TO: Coleman Community Schools – Bidders and Estimators
FROM: Judy Rauch, Project Administrator
DATE: November 26, 2025
PROJECT: 2025 Junior High/High School Renovations
SUBJECT: Addendum No. 2

Addendum No: #2

Project Number: 21-949

Project: Coleman Schools
Coleman JR/SR High School

S2.0

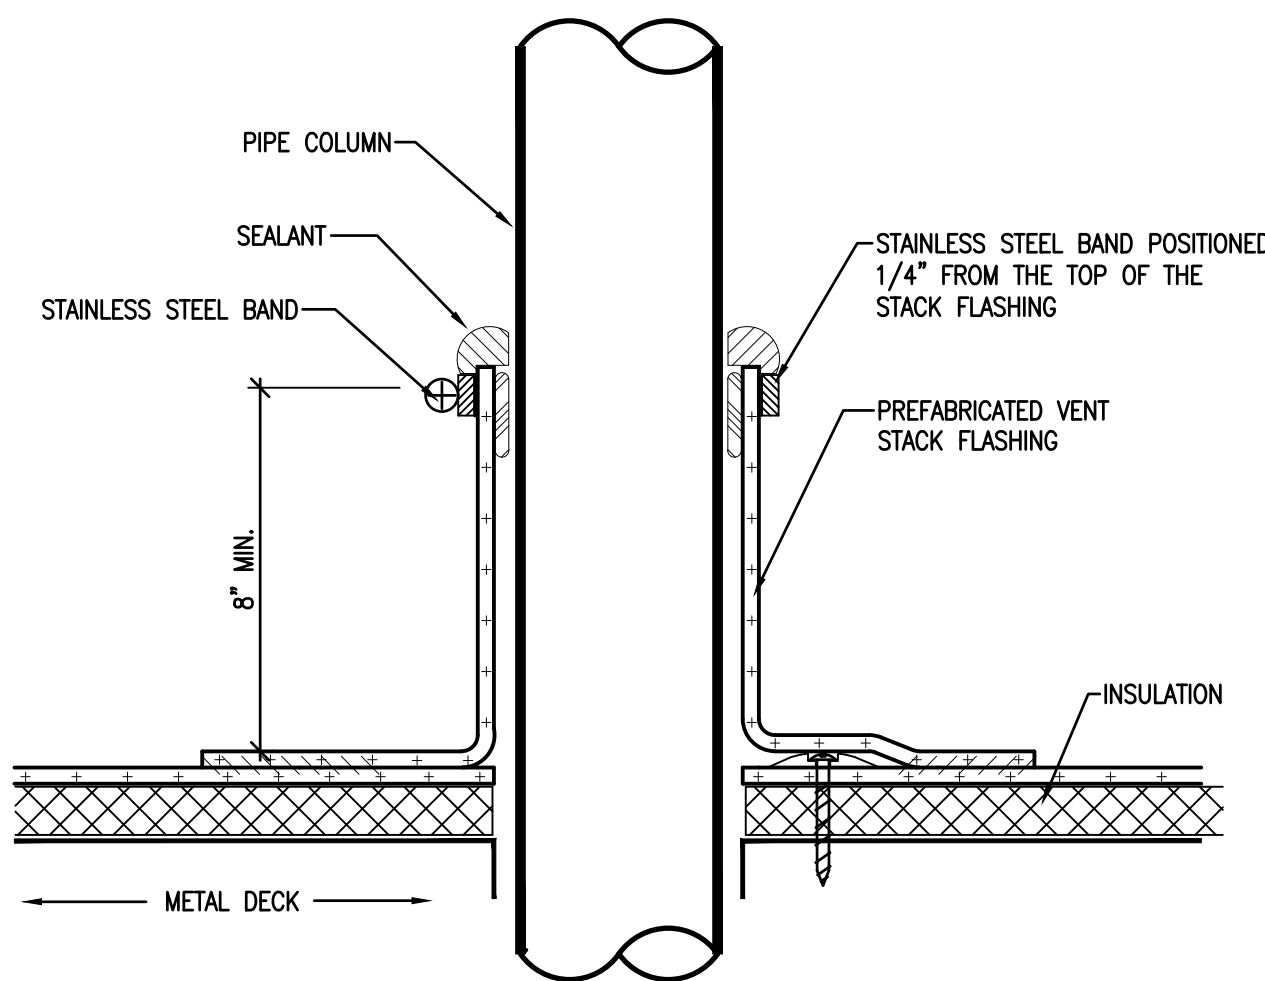
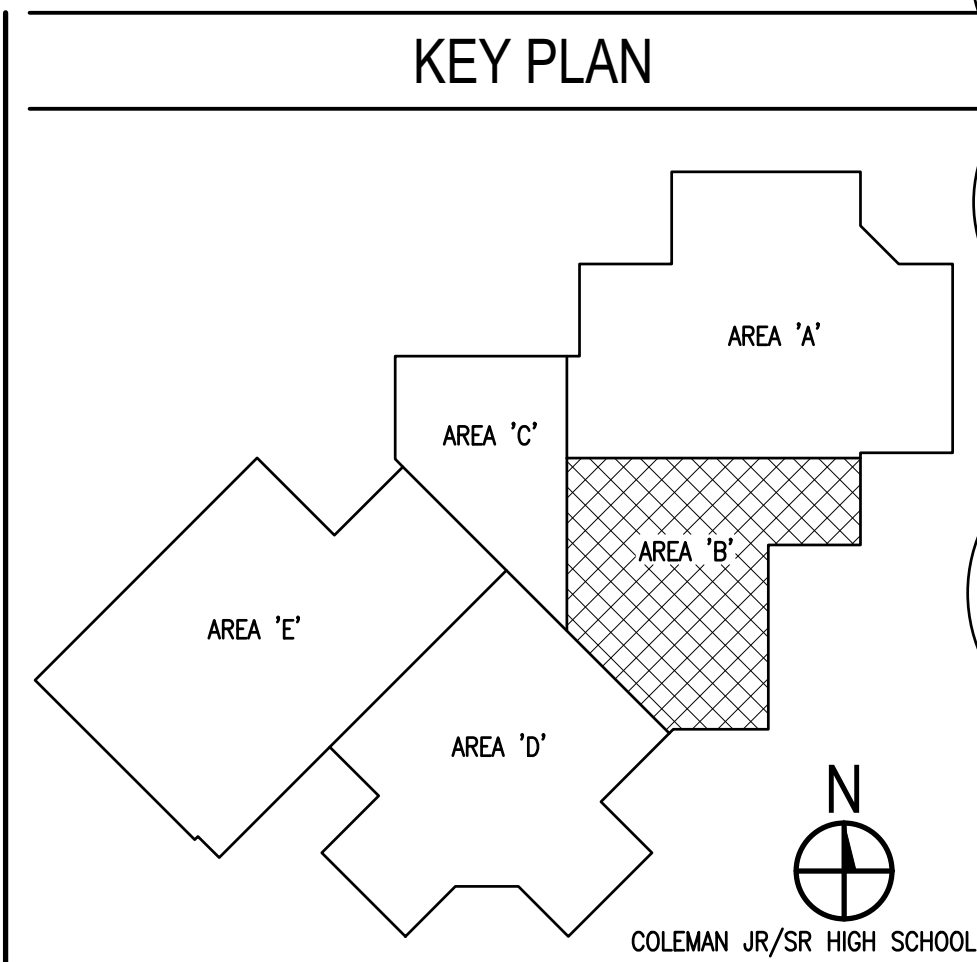
1. S2.0, S2.1, S2.2: Provide angle frame at top of masonry wall as indicated on drawings. See Wall Brace Detail on S2.2. Coordinate with existing structural conditions.

2. S2.0: Revised steel notes per RFI #6 and removed not calling to refer to S4.0.
3. S2.1: Added typical Masonry Notes to sheet.
4. S2.2: Typical joist reinforcing detail provided. Revised masonry details to call out #5 bar.

A7.0

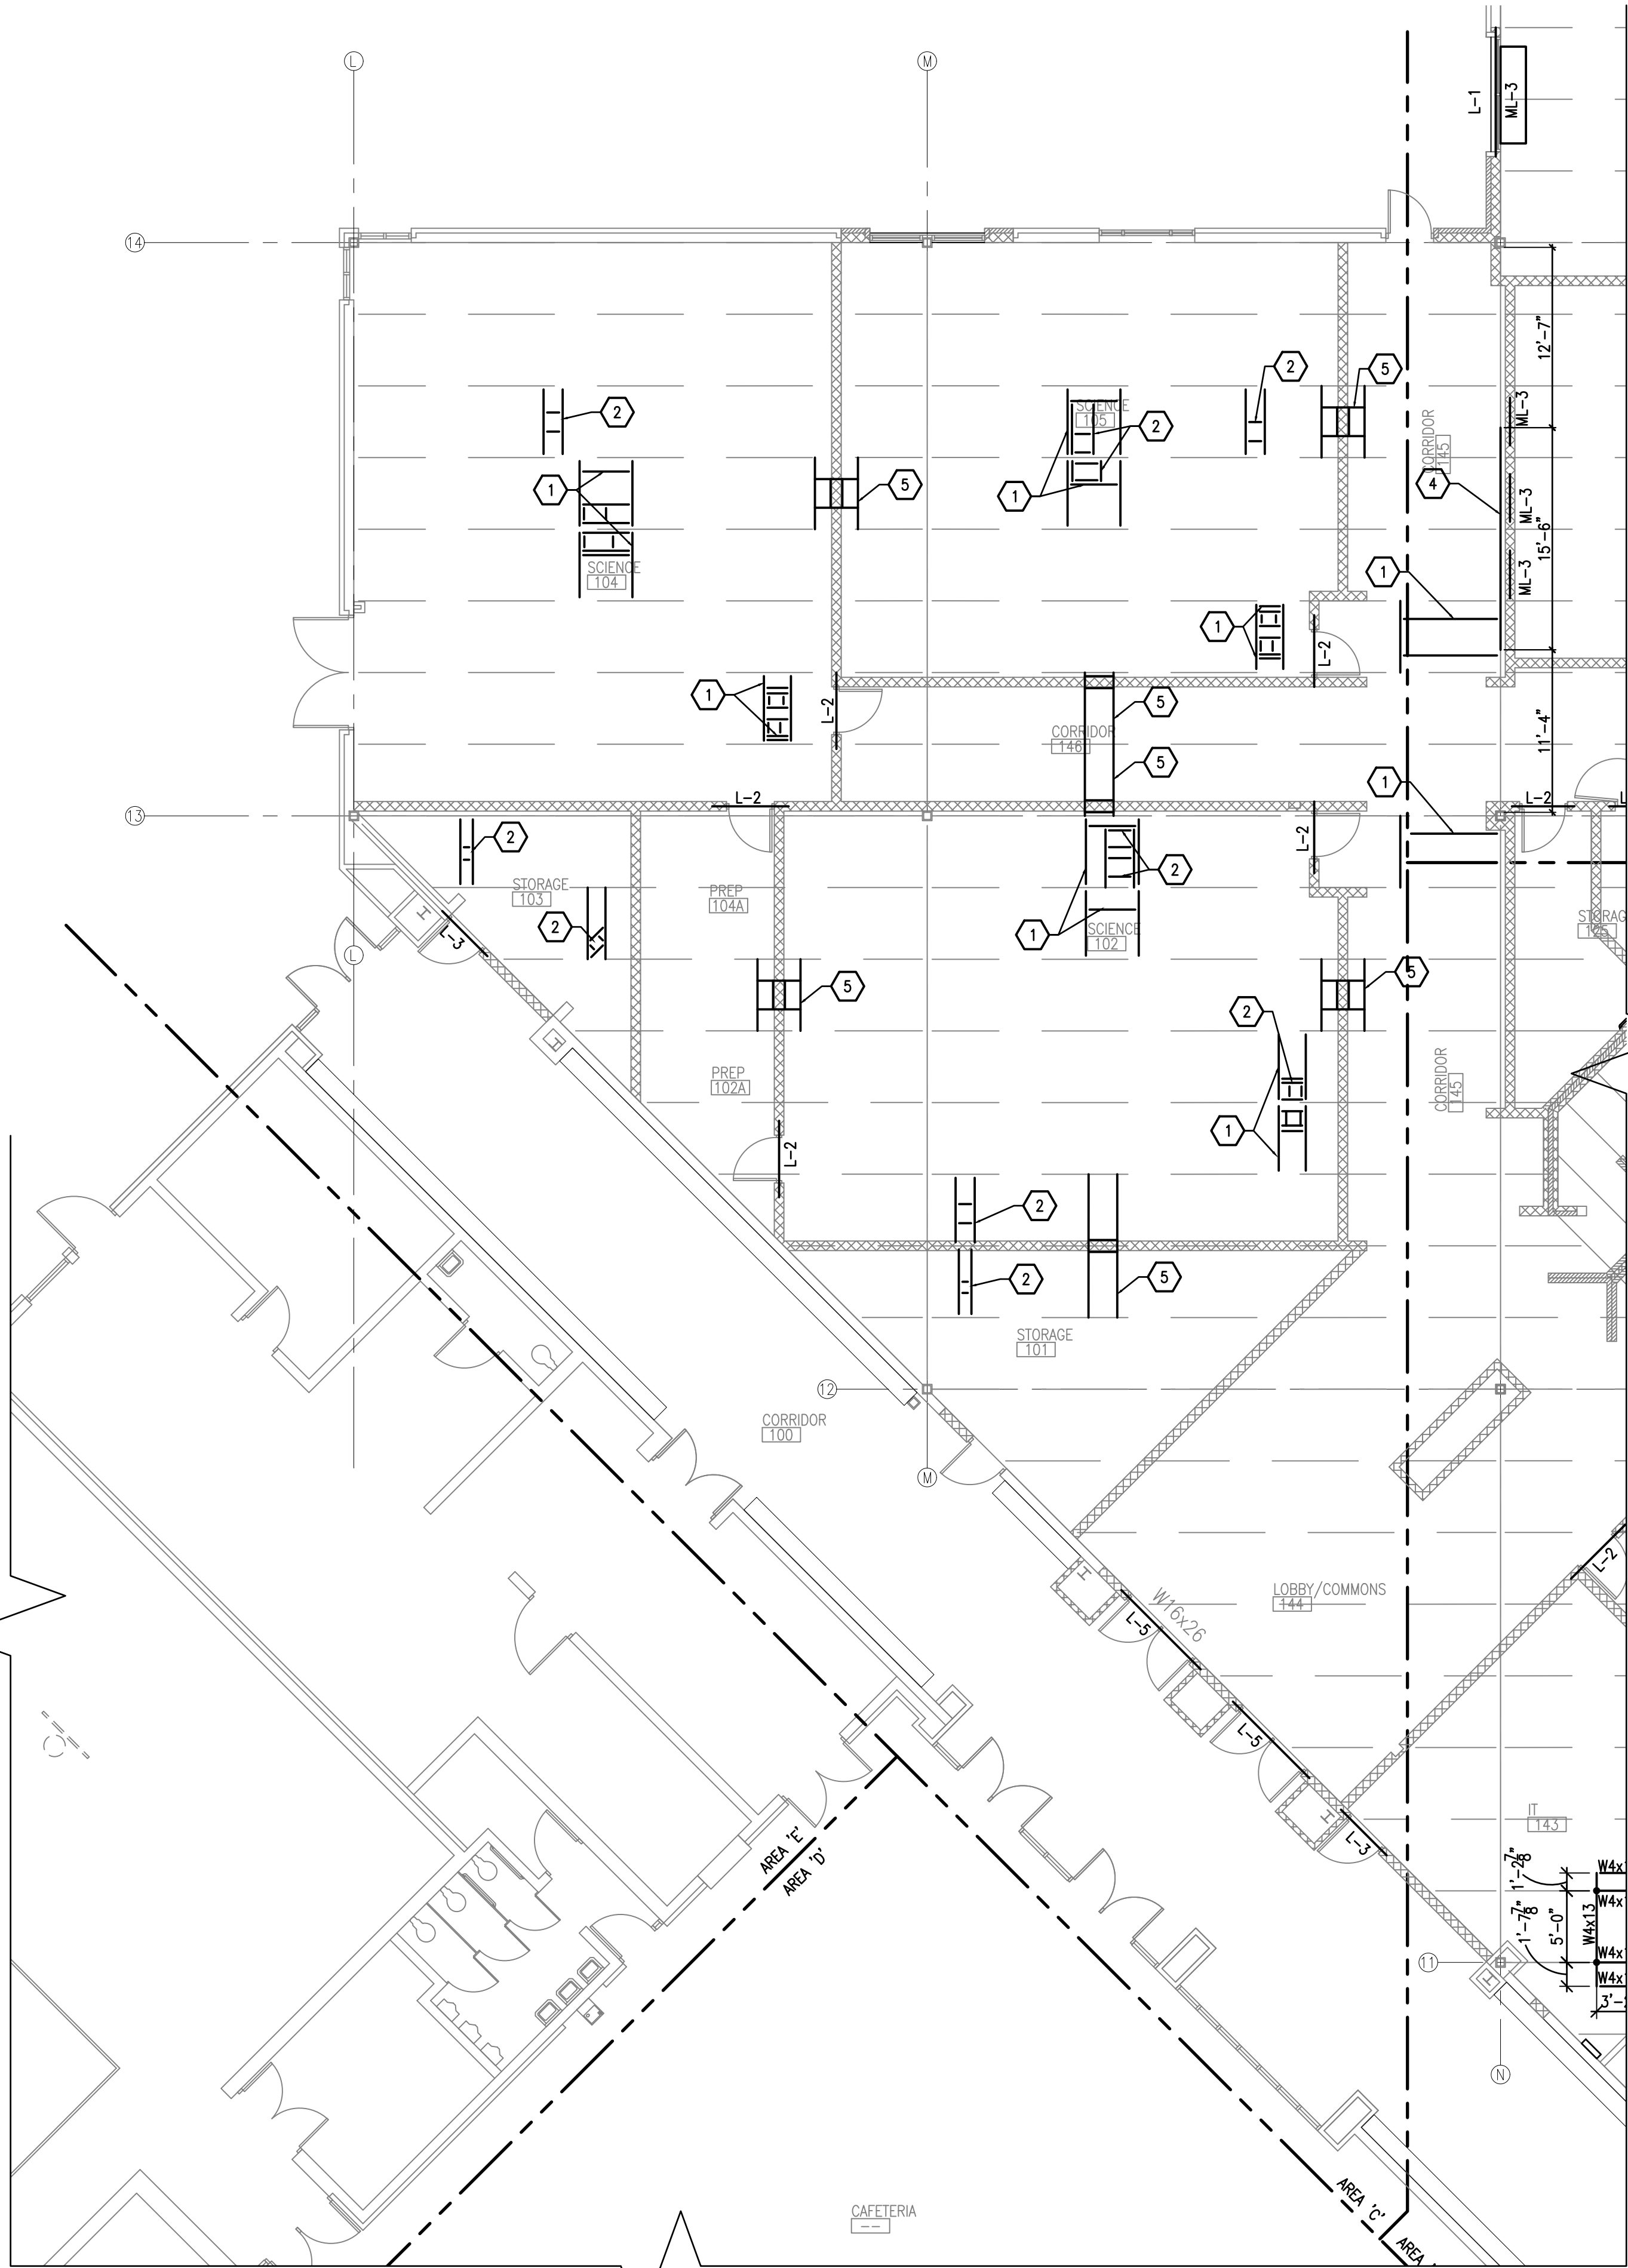
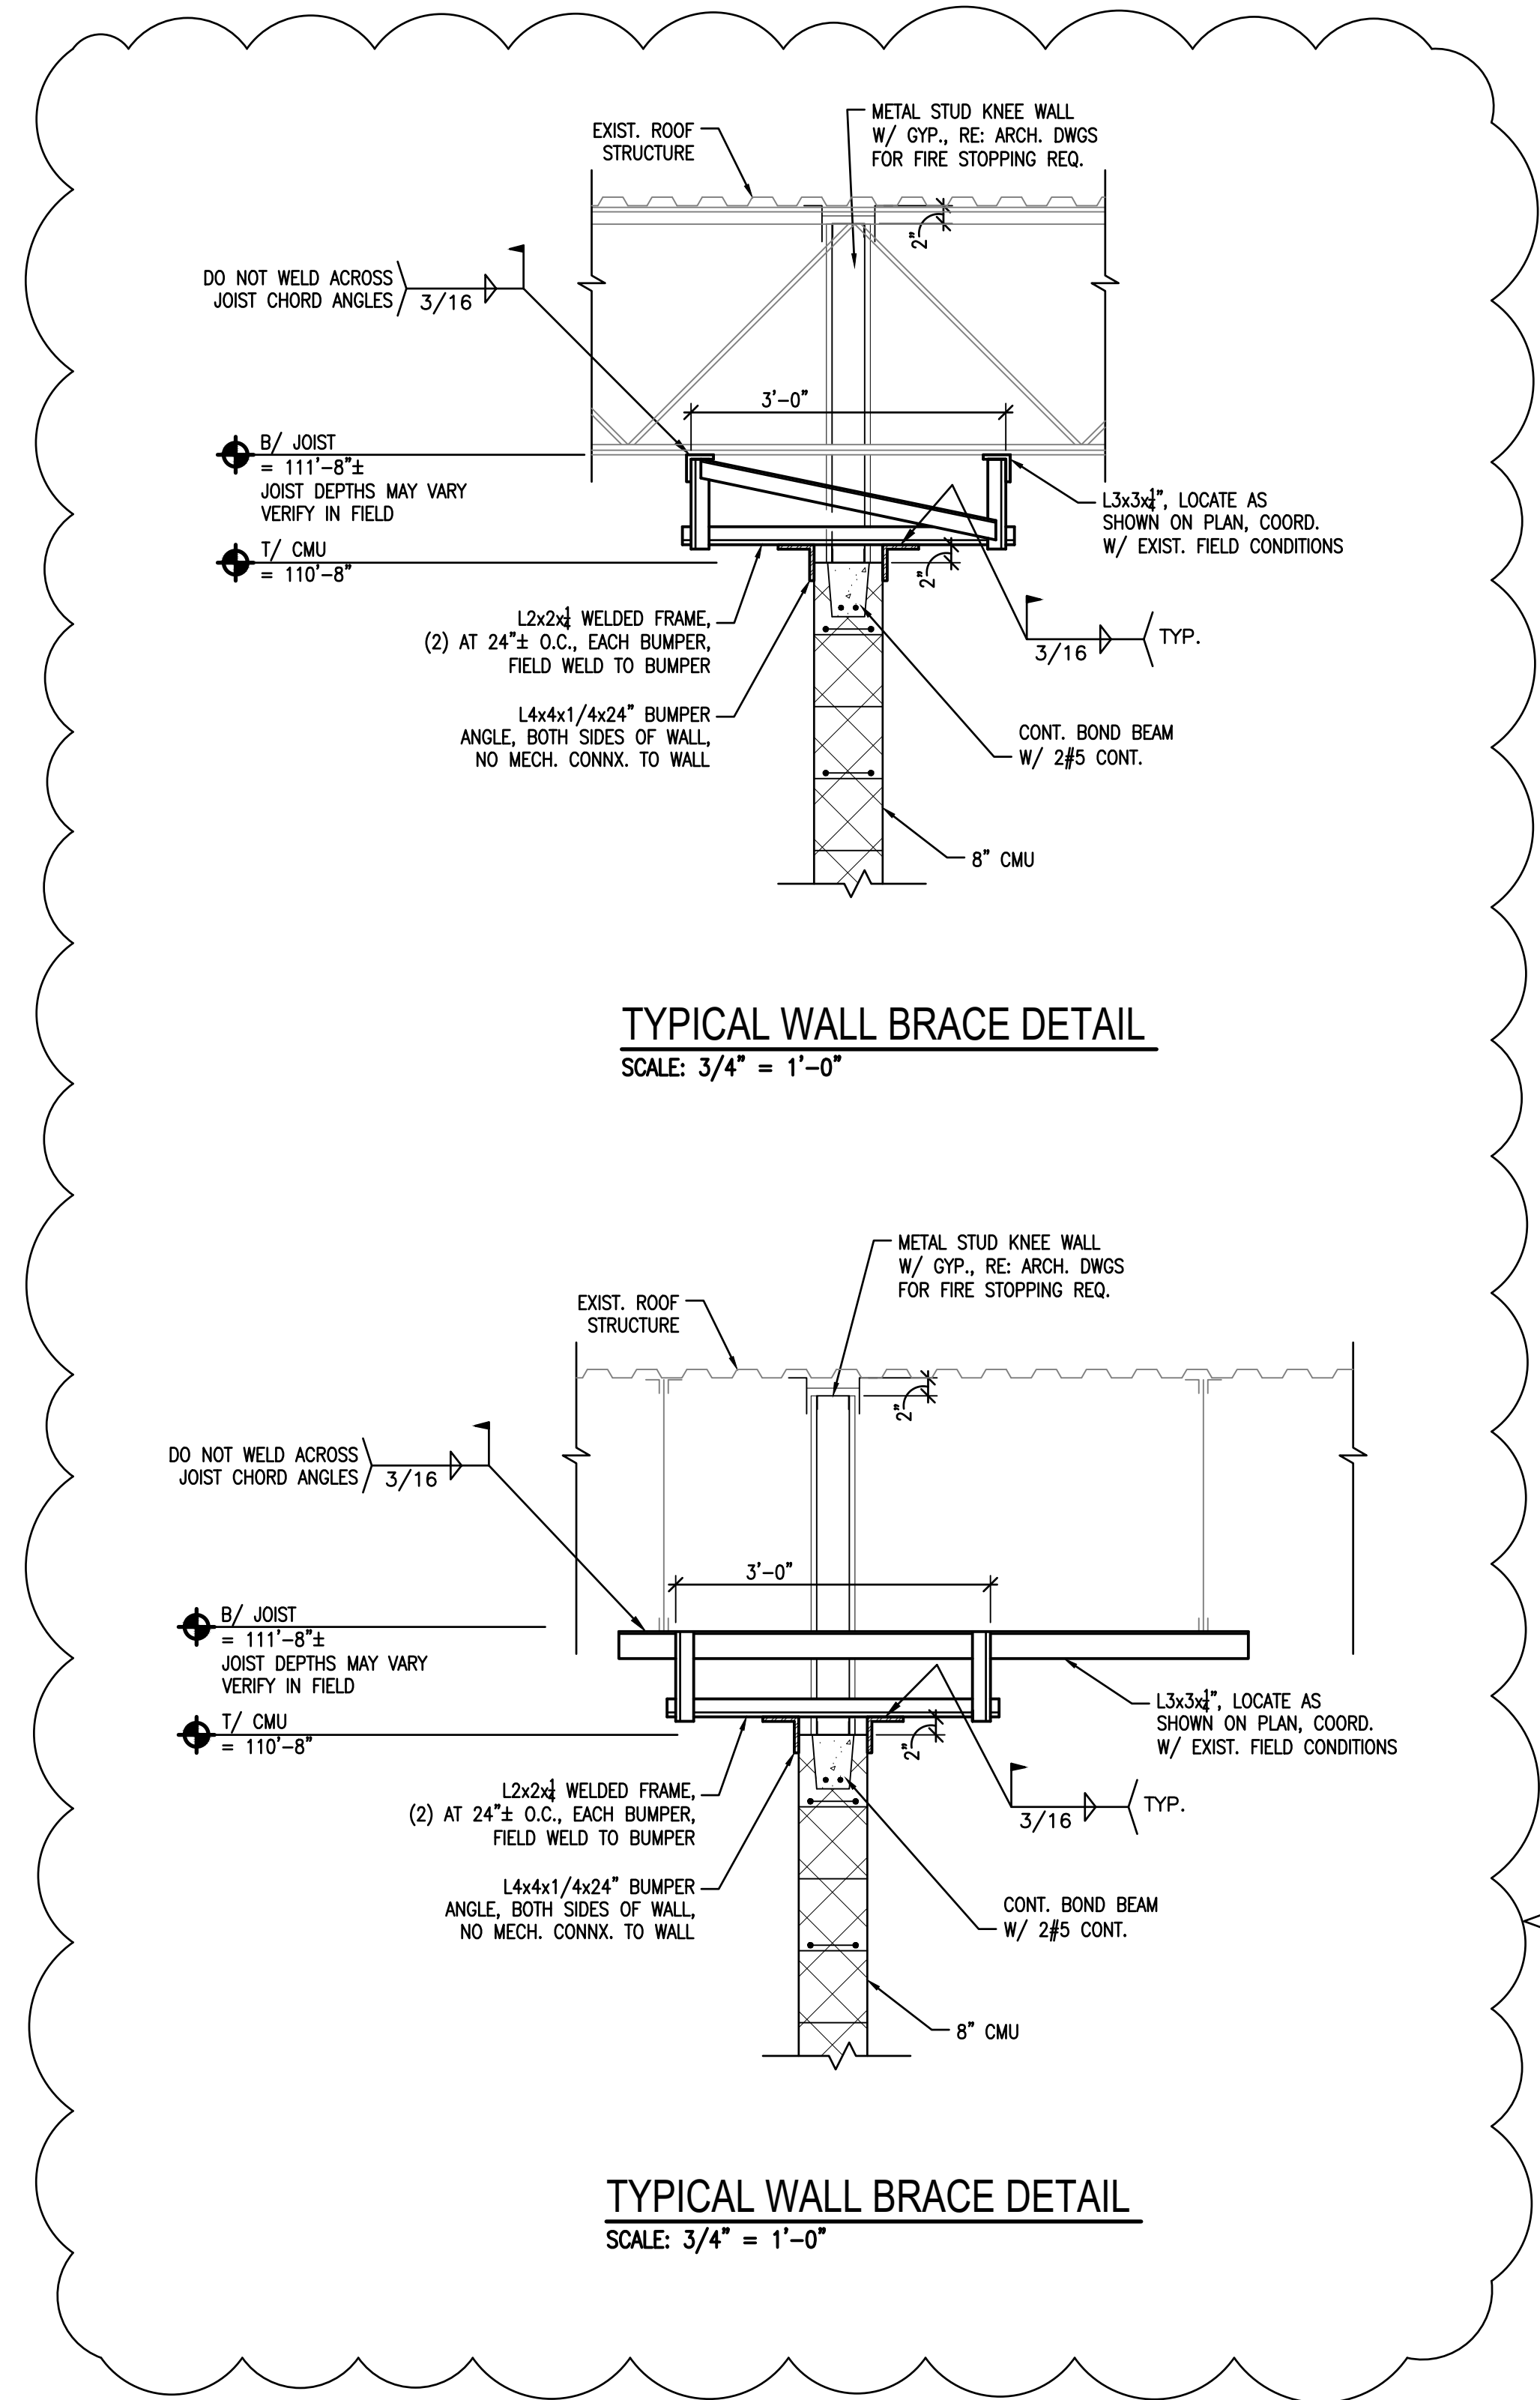
5. A7.0, Door Schedule – Modify door hardware column callouts/reference numbers. Refer to attached sheet A7.0
6. A7.0 Window Schedule: Window Type A, B, C, & D windows will be acceptable as storefront window systems with operable awnings windows inserted in frame system.
